MEMORANDUM

SUBJECT: Meeting at University of Illinois, College of Medicine: Study proposed by University of Illinois at the Taracorp/NL Industries.

U.S. ENVIRONMENTAL PROTECTION AGENCY RESPONSE TO
GENERAL COMMENTS RECEIVED PURSUANT TO THE NOVEMBER 27,
1990, UNILATERAL ADMINISTRATIVE ORDER FOR THE NL
INDUSTRIES/TARACORP SUPERFUND SITE IN GRANITE CITY,
ILLINOIS - JANUARY 1991

Exhibit B

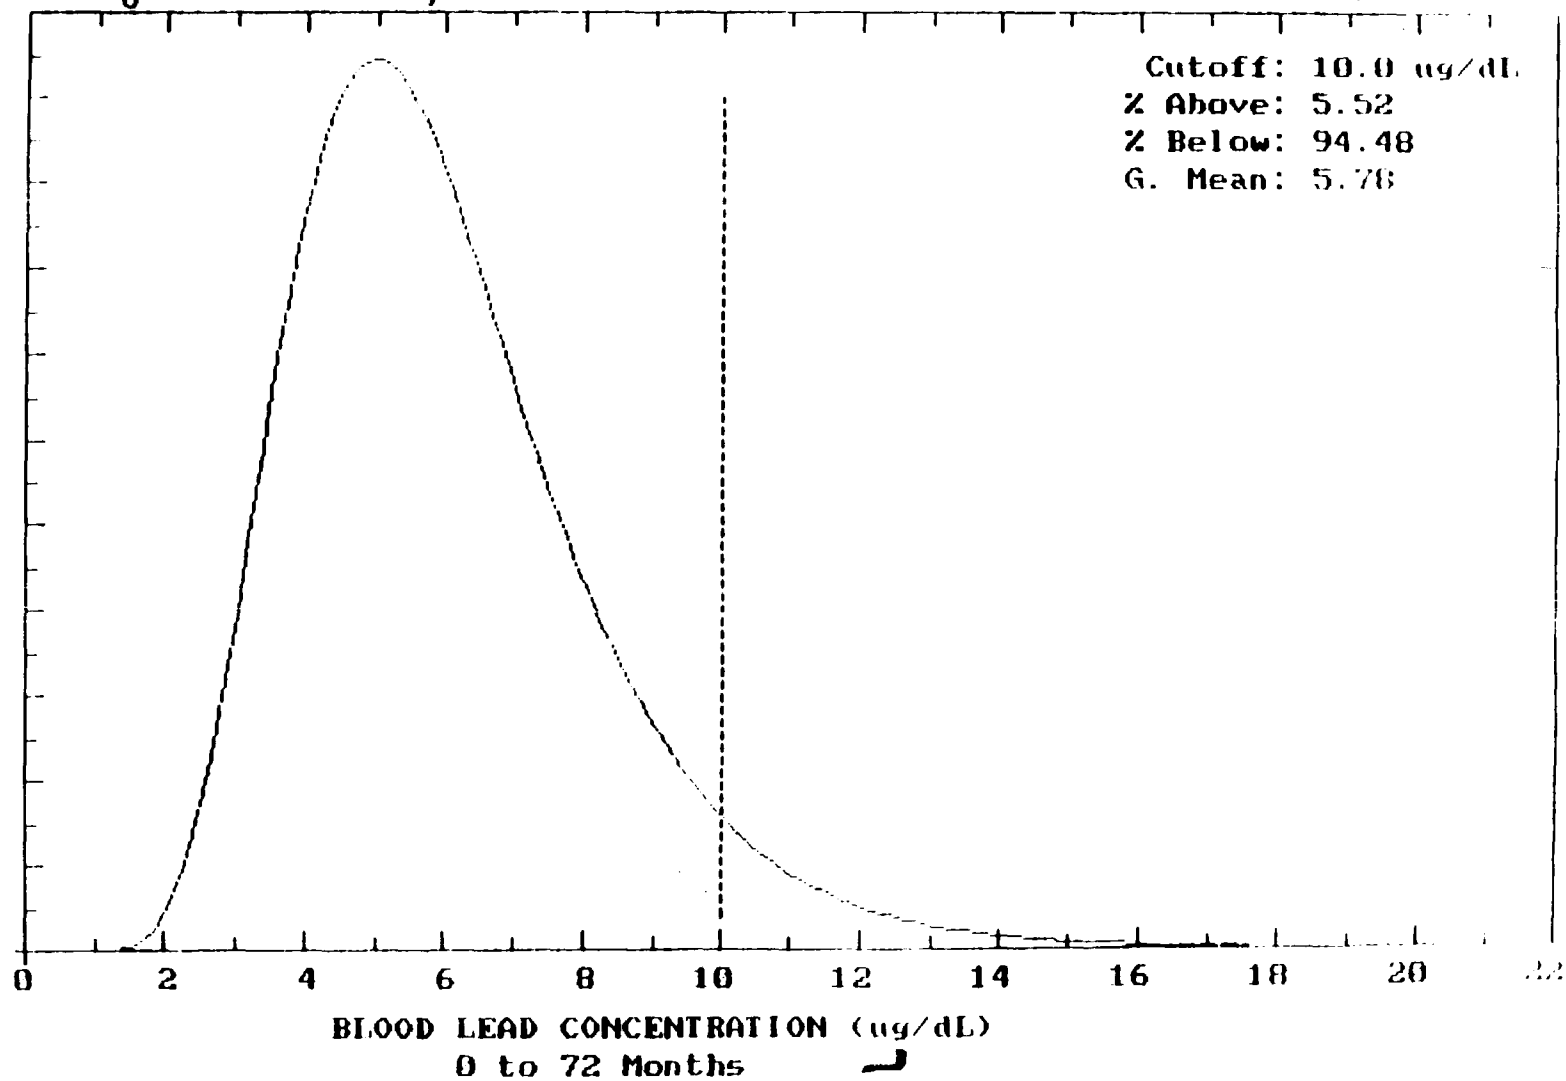
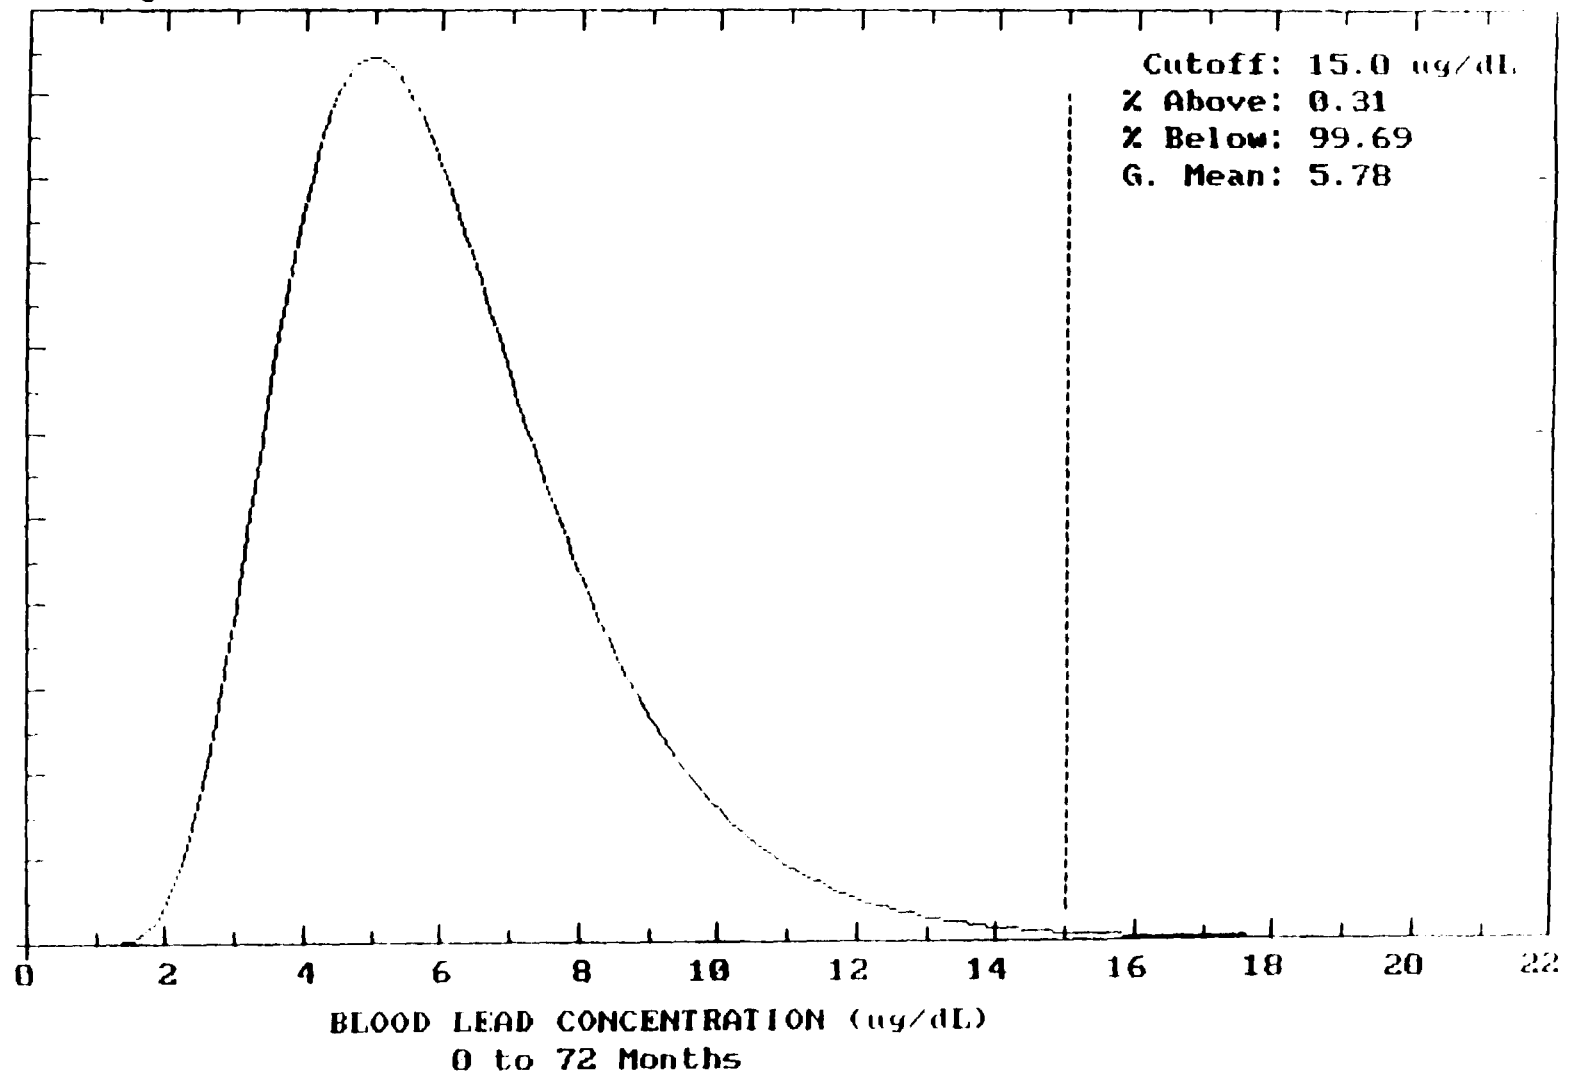
Johnson Controls, in August 1990, submitted untimely comments asking EPA to again consider the use of the U/B Model. These comments were followed in the December 1990 comments Johnson Controls submitted pursuant to the Order, which also contains an extended discussion on the application of the U/B Model. U.S. EPA has rerun the current version of the U/B Model (version 4.0) using currently acceptable toxicological parameters (Exhibit A); the data is included in this presentation. It can be seen that with a 500 ppm soil cleanup level in Granite City, the current version of the model indicates that greater than 5%

of the children will still exceed an acceptable blood lead level of 10 ug/dl. The 10 ug/dl cut-point was previously discussed in EPA's letter to representatives of Johnson Controls dated September 14, 1990.

Exhibit B2

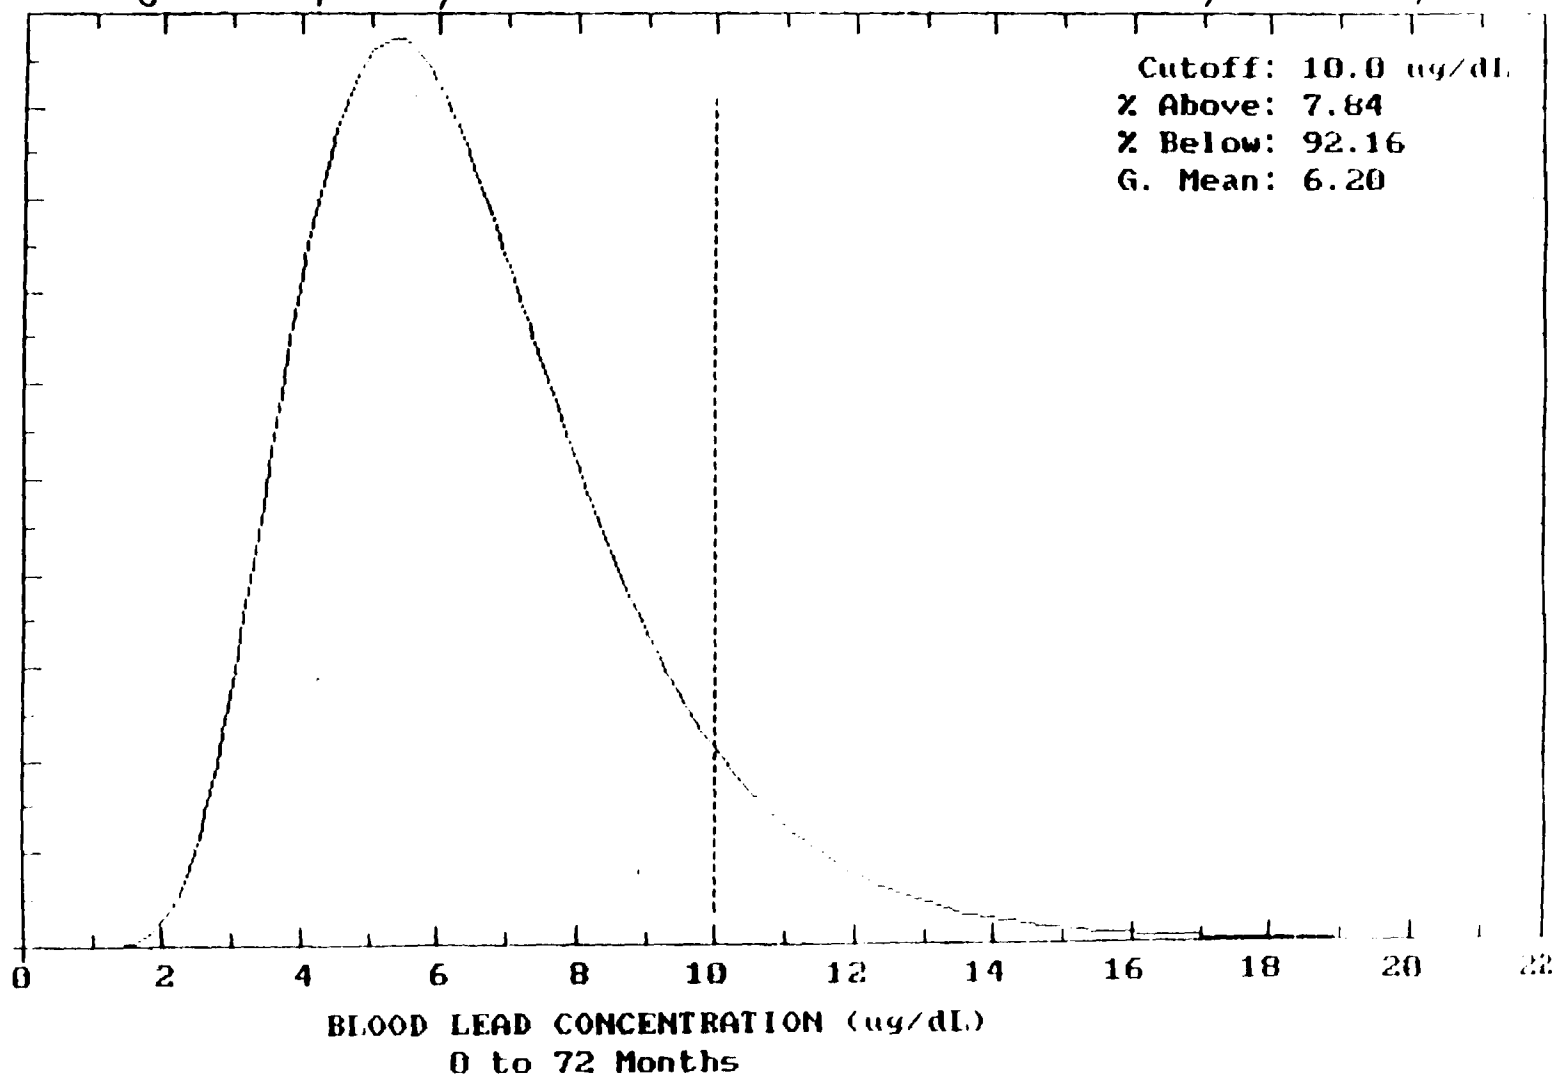
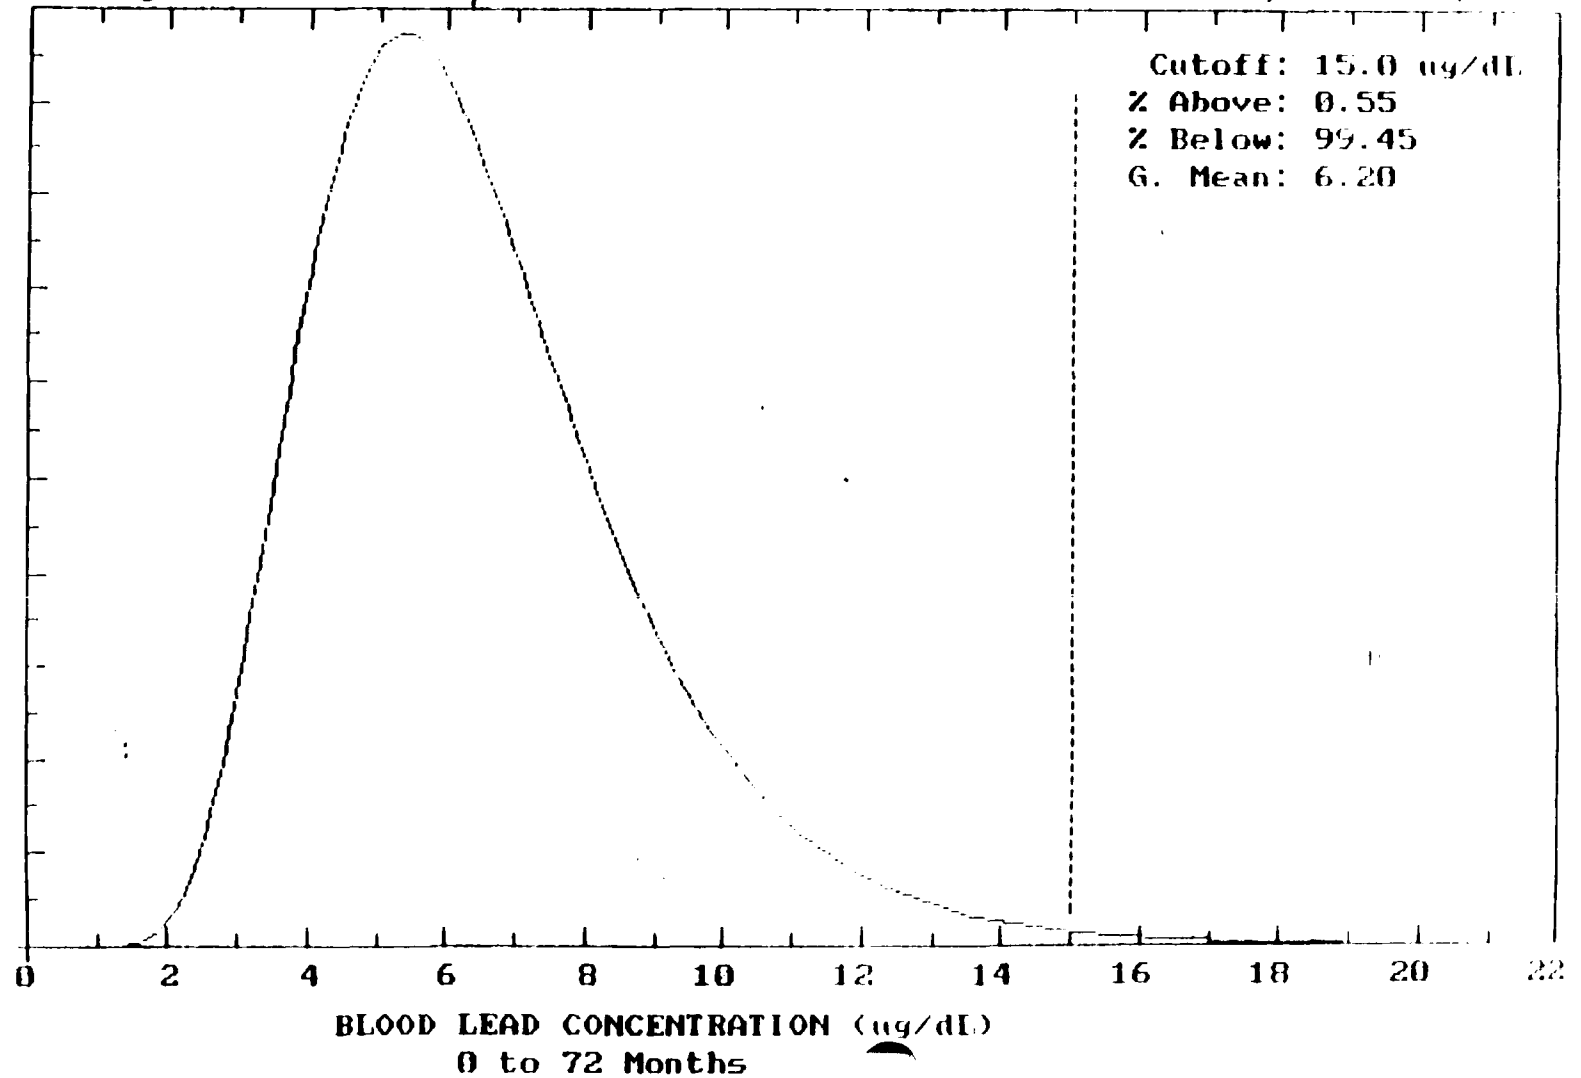
U.S. EPA has also evaluated the use of the U/B Model based on different guidelines currently being discussed at EPA Headquarters; the 500 ppm cleanup standard is the least stringent acceptable cleanup standard under these guidelines. A closer look at EPA's risk assessment approach used for other chemicals at Superfund sites reveals that allowing 5% of the population to suffer from lead poisoning may not be acceptable and clearly is not consistent with the 10^{-6} risk approach generally employed by the Agency. Region V anticipates formal guidance on the use of the U/B Model which adopts an approach to the assessment of risk at lead sites which is consistent with the risk assessment approach for other chemicals at Superfund sites. Official Superfund guidance may soon stipulate that 99.5% of the exposed children in lead-contaminated Superfund sites must maintain blood-lead levels below 15 ug/dl rather than requiring 95% of the children to measure less than 10 ug/dl. This curve is also included as Exhibit B. Under either scenario at the NL/Taracorp Superfund Site, however, the 500 ppm lead cleanup level selected for the Site is appropriate and the maximum allowable level to prevent undesirable health effects in the children living in this area.
